ADDENDUM NO. 2 TO PROJECT NO. 44854

**CONSTRUCTION, HVAC WORK, PLUMBING WORK, ELECTRICAL WORK
PROVIDE CENTRAL SECURITY UNIT, BUILDING No. 51
HIGHLAND RESIDENTIAL CENTER
629 NORTH CHODIKEE LAKE ROAD
HIGHLAND, NY 12528**

February 4, 2016

DRAWING NUMBER:
 FA-101

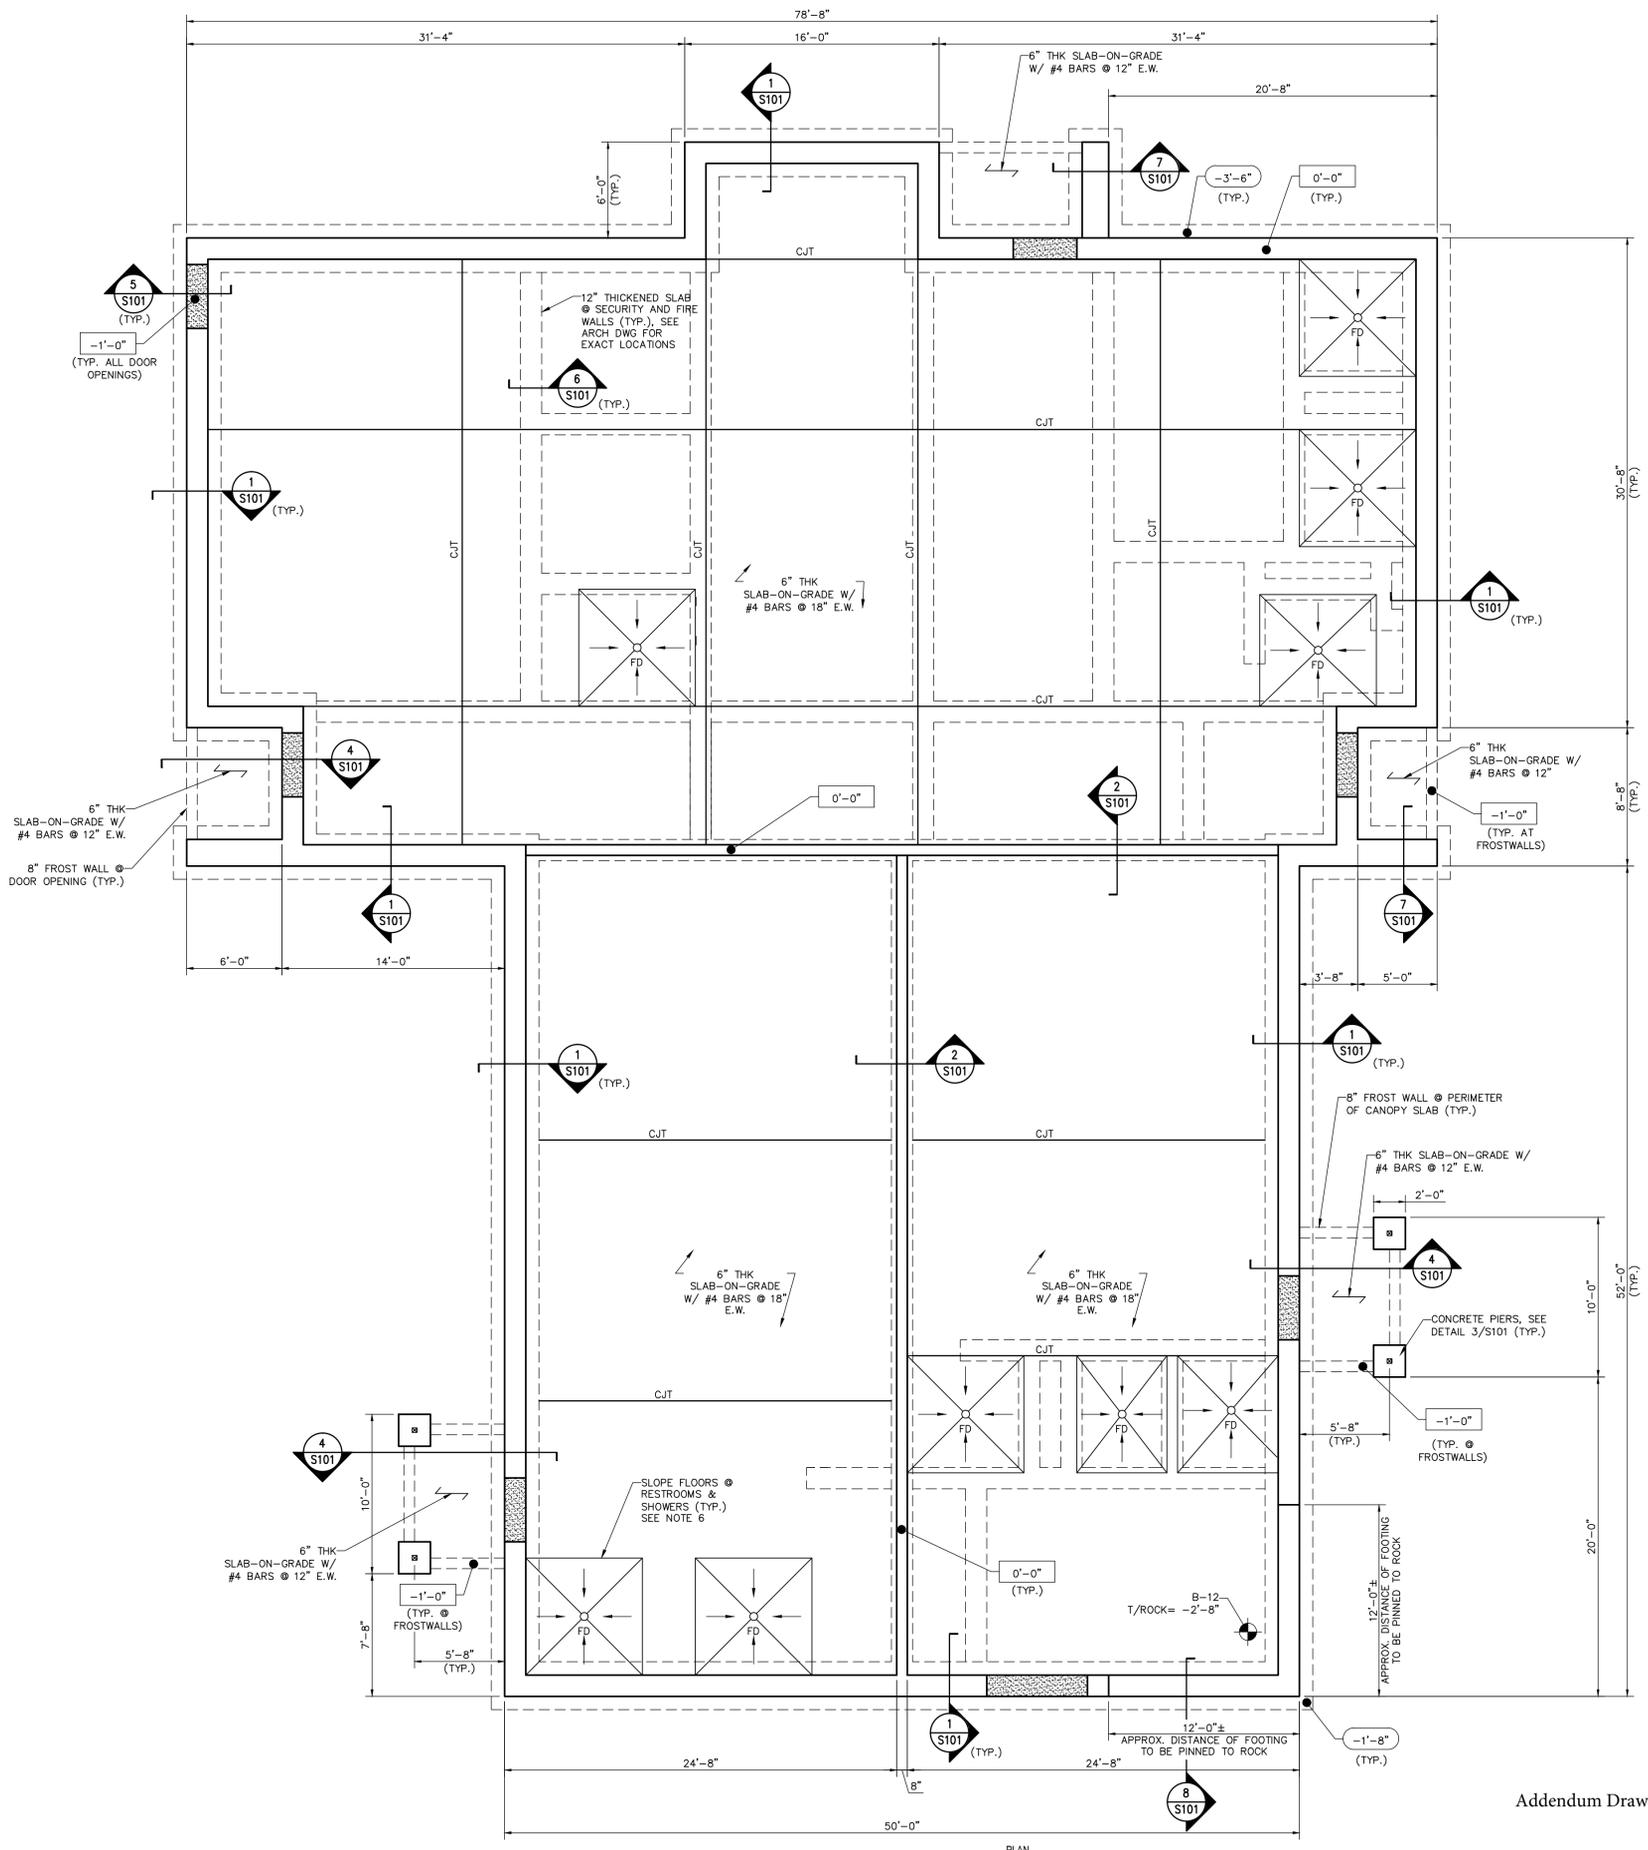
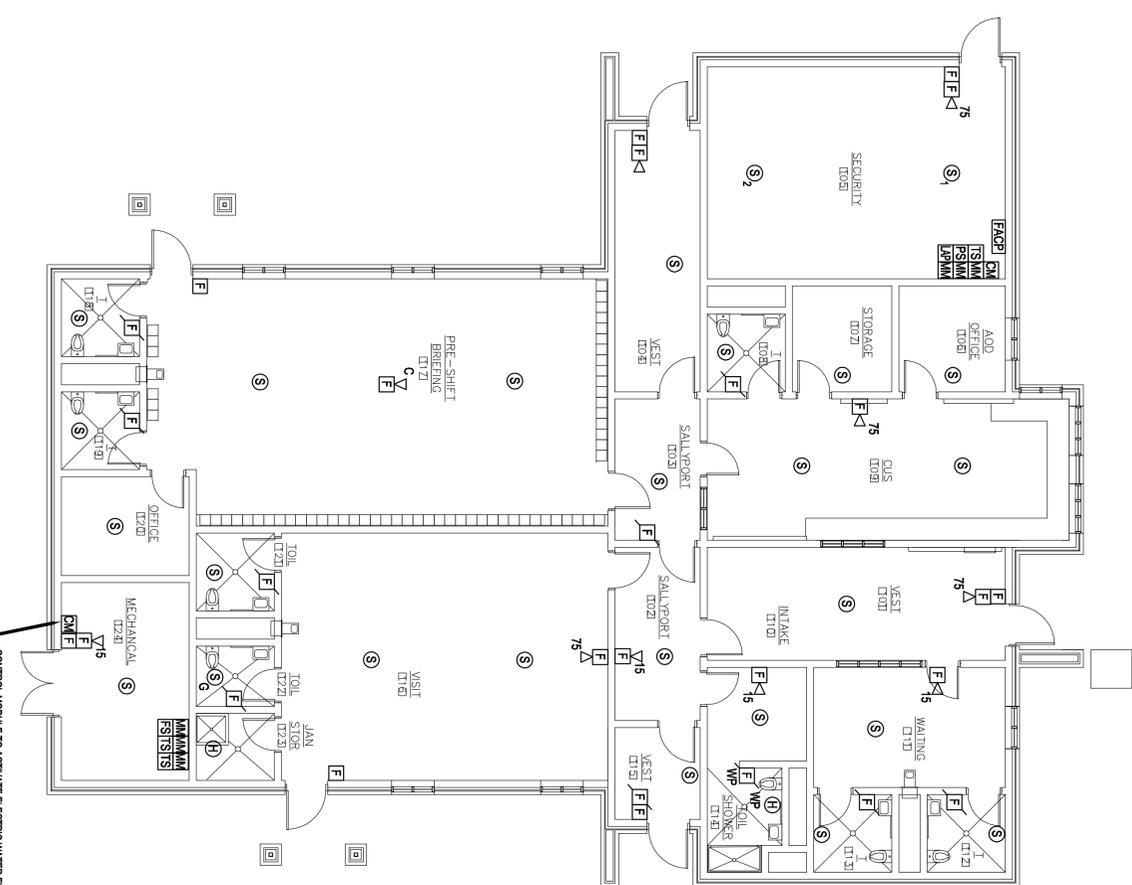
3. Revised Drawing:
 - a. Drawing No. FA-101 noted "02/04/2016 REVISED DRAWING" accompanies this Addendum and replaces the same numbered originally issued drawing.
